December 29, 1981
LD-81-098

Subject: Organizational Changes in Combustion Engineering Quality Assurance Program

Figure 17-1 (11/81)

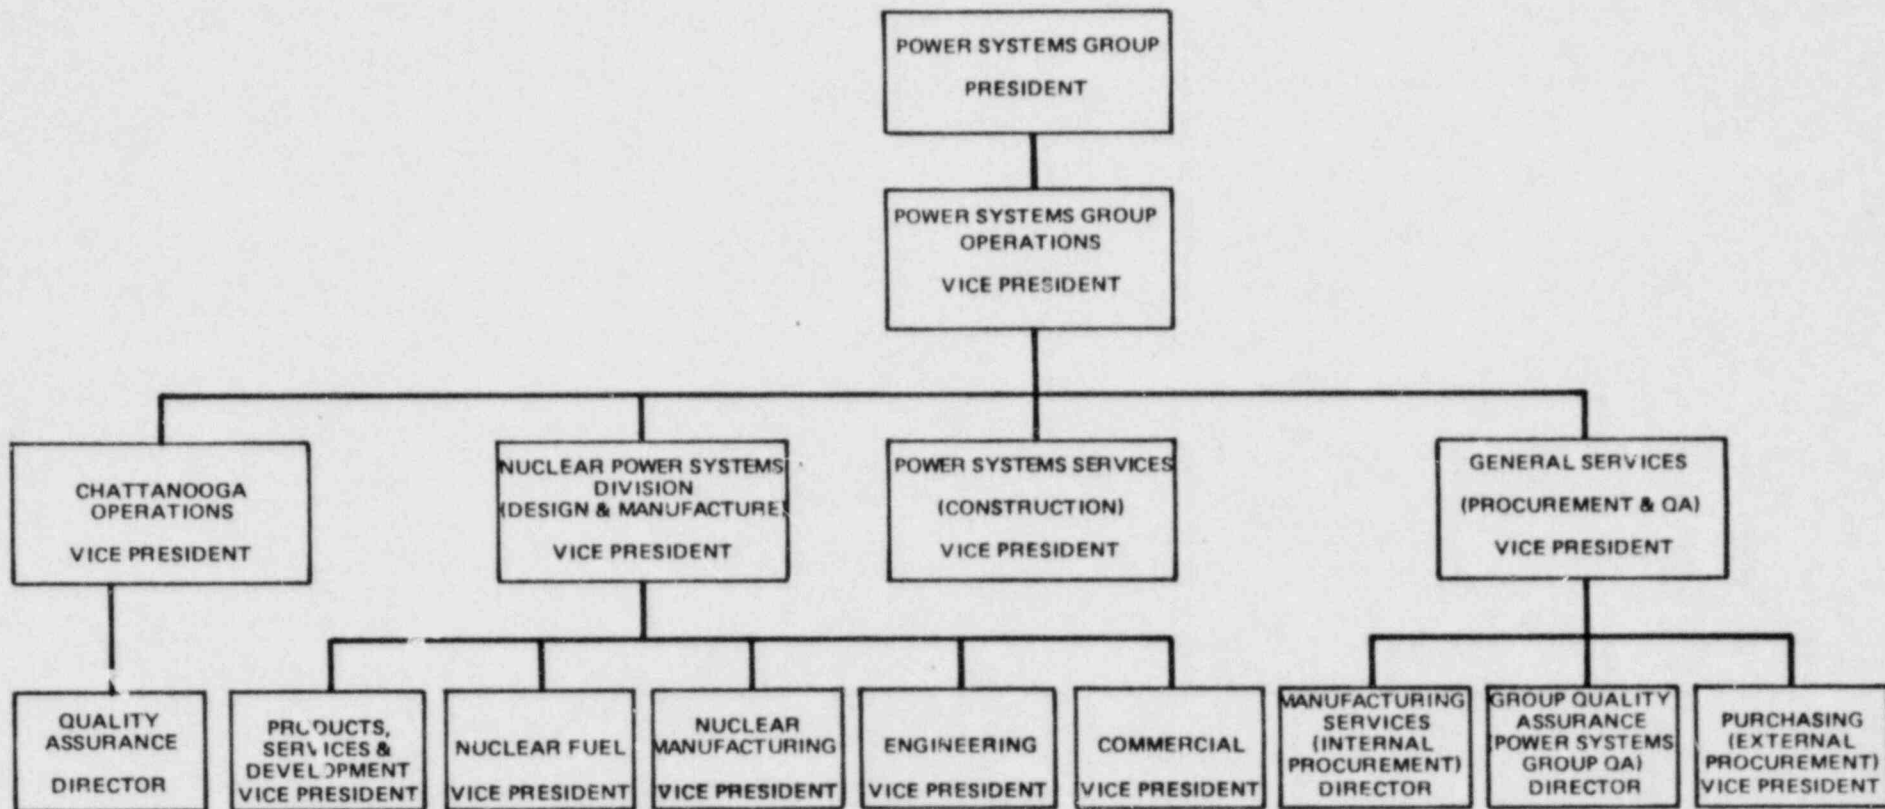
- Figure 17-1 - Nuclear and fossil activities at the Chattanooga, TN manufacturing facility have been consolidated under the Vice President, Chattanooga Operations. The quality assurance responsibilities have also been consolidated under the Quality Assurance Director, who reports directly to the Vice President Operations.
- Figure 17-2 - A realignment of responsibilities within Group Quality Control resulted in dedication of one section primarily for supplier audits and surveys.
- Figure 17-3 - The Engineering Quality Assurance (EQA) Manager now reports directly to the Vice President of Engineering. The responsibilities of the Manager of EQA remain as described in CENPD-210-A.
- Figure 17-5 - The responsibilities of the Q. A. Groups remain as described in CENPD-210-A.
